**MEMORANDUM**

REVIEW TYPE: **Site Plan Review**  
 CASE #: **8-05019**  
 PROJECT NAME: **Royco's Addition to Derwood, Parcel E**  
 APPLYING FOR: Approval of 69,220 square feet of automobile dealership space  
 REVIEW BASIS: Automobile sale uses in the I-1 zone are subject to site plan review per Sec. 59-C-5.21 of the Zoning Ordinance

staff recommended streetscape section

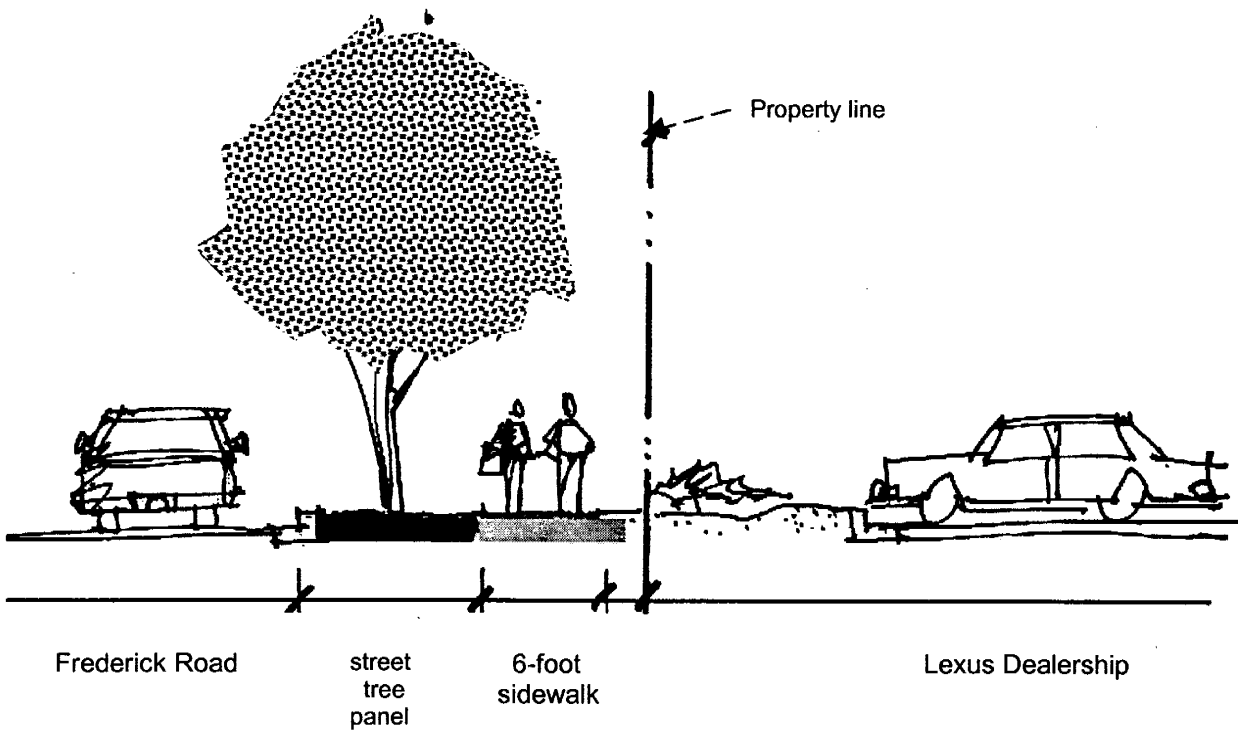
Staff recommends relocation of the sidewalk to provide a six-foot-wide grass panel for street tree planting and to provide a safe pedestrian walkway from highway traffic (see street section diagram on page 5). Street trees should be planted within the six-foot grass panel adjacent to the curb.

The proposed redevelopment of the site represents an opportunity to rebuild the pedestrian environment along MD 355 in accordance with county standards. The frontage along MD 355 is approximately 390 linear feet, over the length of a football field.

The Planning Board (2004) Shady Grove Sector Plan recommends upgrading the streetscape along the entire MD 355 corridor given the proximity to Metro, need for safer pedestrian access and the importance of MD 355 as a “Main Street” within Montgomery County. In MD 355 South Corridor, the Planning Board Plan endorses a “curbside lawn panel to separate pedestrians from moving traffic” and to “provide a six-foot wide sidewalk at a minimum” (p.77).
